Re: Arlington Storage Company, LLC, Seneca Lake Storage Facility Gallery 2 Expansion Project, Docket CP13-83, Expert Geologist Report

January 15, 2014

FIGURE 2 PROFILE OF WATKINS GLEN
BRINE WELLS Nos 27, 28, & 30

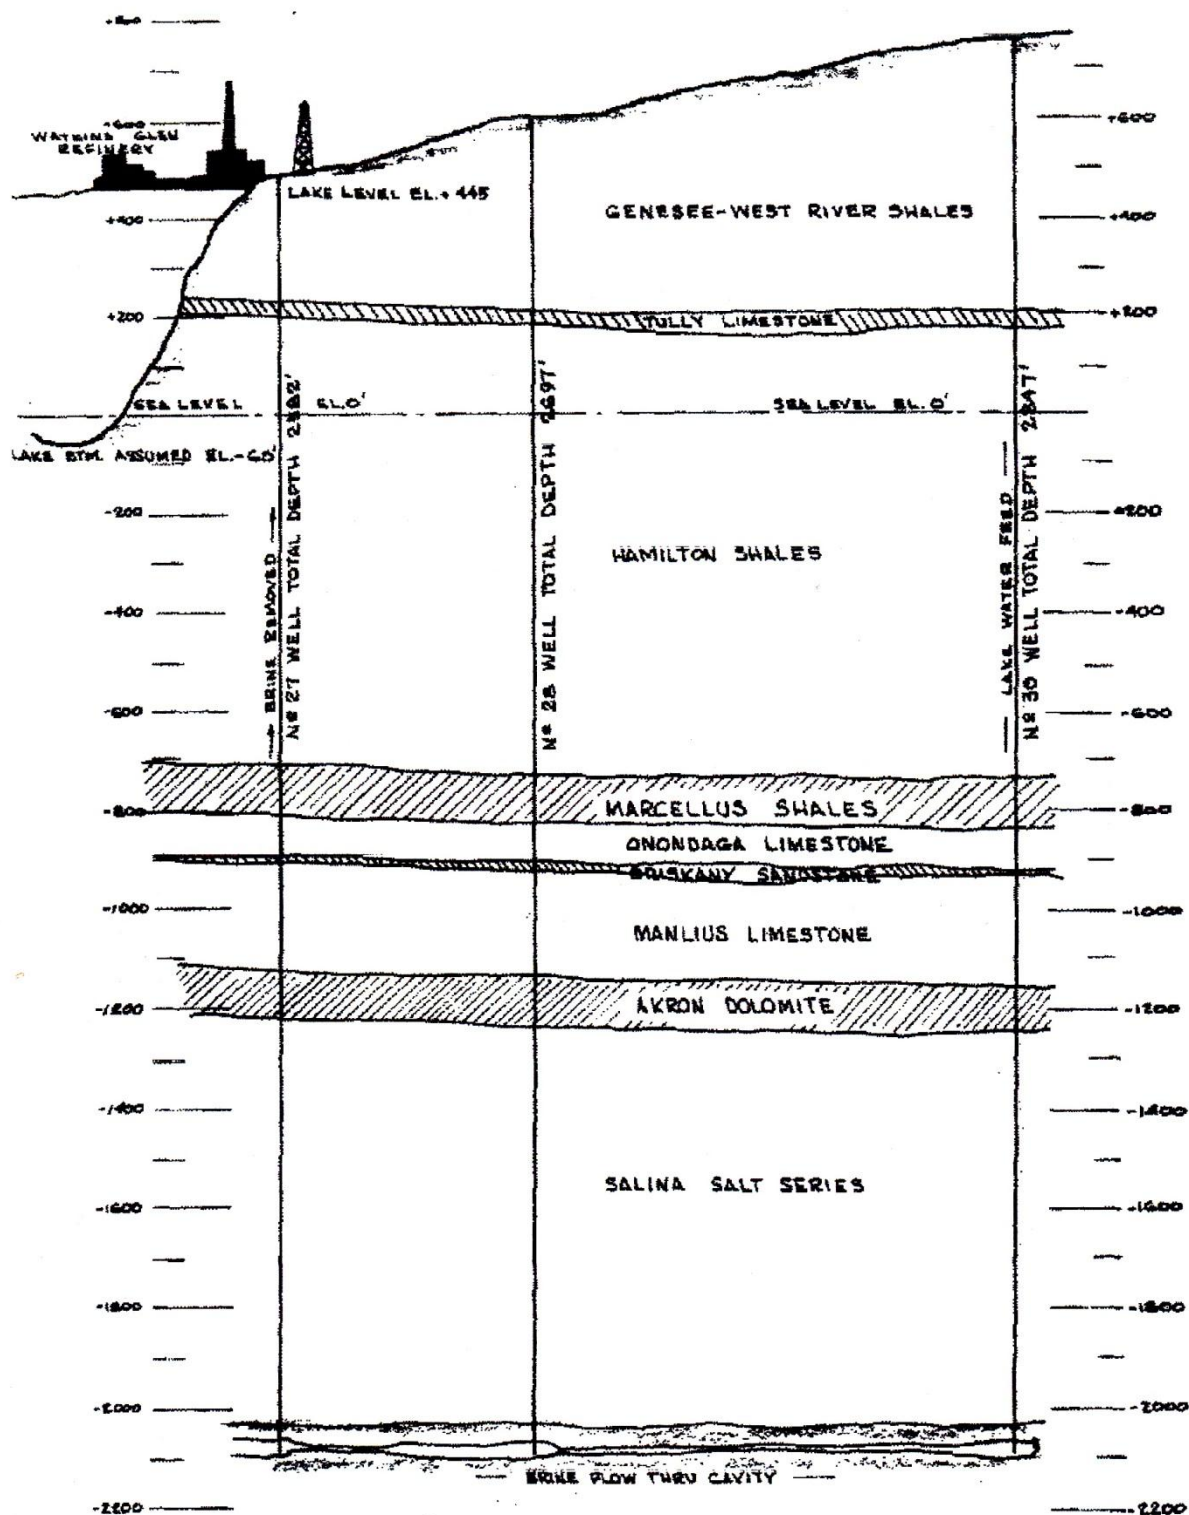
The next cross-section from the Jacoby 1969 paper (his Figure 2, attached as Exhibit 3) shows the situation in June of 1964. Initially, Well 30 and Well 31 were both hydraulically fractured at the lower B2 salt layer, but the process failed to connect the two wells by way of the lower B2 salt (see near-well fracture at wellbore depicted at the lower B2 of Well 31). “The connection between the two wells was finally completed in the **fault zone** in the **overthrust block** of B2 salt.” (Jacoby, 1969) (emphasis added). Jacoby wrote extensively about using an understanding of this thrust fault geology to design hydraulic fracture programs and to take advantage of a weakened fault zone path to a target well. And with regard to these wells, he notes: “At the points on the cross-section where faulting has been confirmed, fault zones several feet in thickness are present.” (Jacoby, 1969) Following fracturing, communication was established between Wells 30 and 31 and Gallery 2 solutioning development began. The cross-section of Jacoby’s Figure 2 shows that the two connected caverns were being used for LPG

storage in 1964 as shown by the propane legend symbol in the upper part of Cavern 31 and at the top of Cavern 30. The vertical extent of the hydraulically fractured fault zone connecting Cavern 30 to Cavern 31 is discussed only qualitatively in the paper, but the areal extent of the hydraulic fracture connection must be significant since publicly available mapping⁵ shows Well 45 to be offset from a straight line connecting Wells 30 and 31, and it intercepts the fractured fault zone connection and will be used in the Arlington plan as a monitor well. While on the subject of the hydraulically fractured connection between Wells 30 and 31, there is a cross-section in another Jacoby paper that shows a connection between Well 30, Well 27, and Well 28 (Jacoby, 1961, Figure 2 attached as Exhibit 4). That paper is a discussion of the brine mining process and the wells are not discussed specifically. If there is or was a connection, that would connect Gallery 2 to Gallery 1, and this would be a significant concern. Arlington must have all the original records, and it could provide that information from the original source to resolve this question. The connection by way of a fault zone that affects both Well 30 and Well 31 and beyond, and perhaps way beyond, is not discussed in the public Arlington documents that I have reviewed.

Exhibit 5

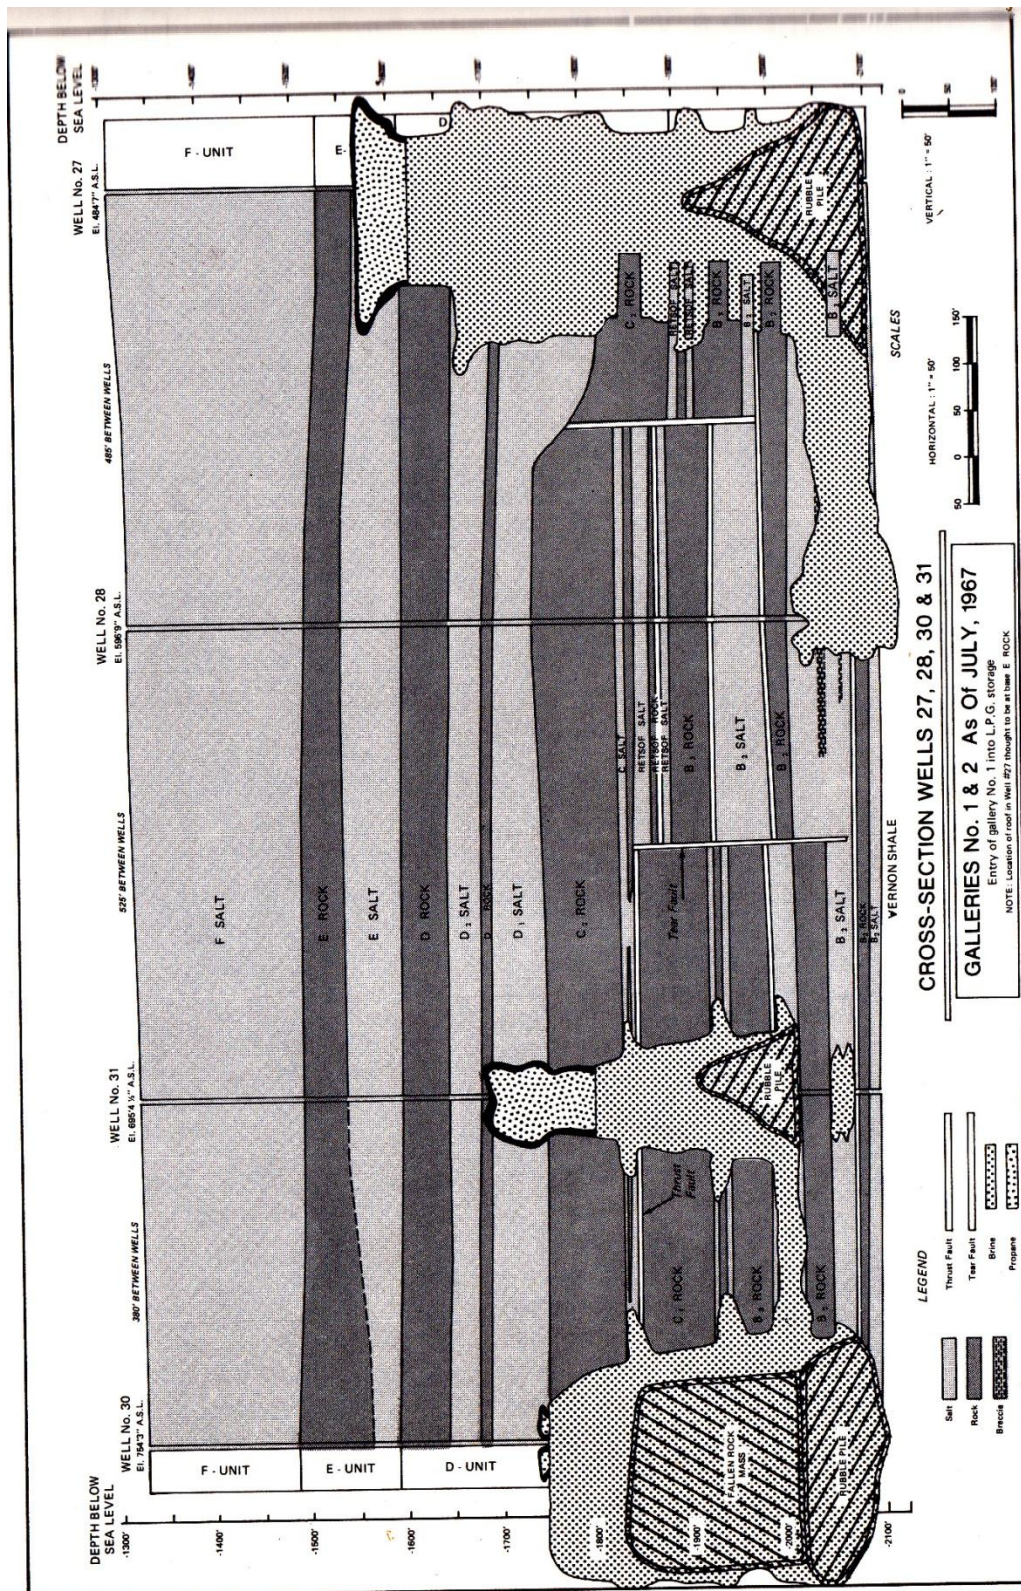
By July of 1967, the date of the next cross-section, both Gallery 2 (Cavern 30 connected to Cavern 31) and Gallery 1 (Cavern 27 connected to Cavern 28) were being used for LPG storage. (Jacoby Figure 3, attached as Exhibit 5). By this time, the caverns had expanded, leaching salt and accumulating rubble where interbedded unsupported rock layers had fallen. Jacoby depicts the four caverns filled with a combination of brine, propane, and rubble. In perhaps the most striking revelation of this review, there is a large intact block in Cavern 30 with a suspicious jig-saw puzzle fit to the cavern outline above and noted as “Fallen Rock Mass” on the cross-section. That is, Cavern 30’s roof failed, and the rock fall was dramatic. This is explained by Jacoby as a lesson to use saturated brine in cycling product out of the caverns:

Unless saturated brine is used continually in recycling the product, there is distinct possibility of undermining **fault blocks**. Illustrated in (Jacoby) Figure 3 is a large block of rock calculated to weigh over **400,000 tons** which **fell from the roof** even with the use of saturated brine.

(Jacoby, 1969) (emphasis added). Perhaps anticipating, even then, an attempt to discredit this cavern roof rock fall event, he went on to say: “This portion of the cavity was outlined by using sonar surveying equipment.” The parallel between the fault block cavern roof failure in Cavern 30 and the roof collapse in Cavern 58 is obvious. It is clear that researchers working on caverns in the Watkins Glen brine field have encountered cavern roof failures and attributed these failures to fault situations. It is essential that cavern roof failure in the Watkins Glen brine field be recognized.
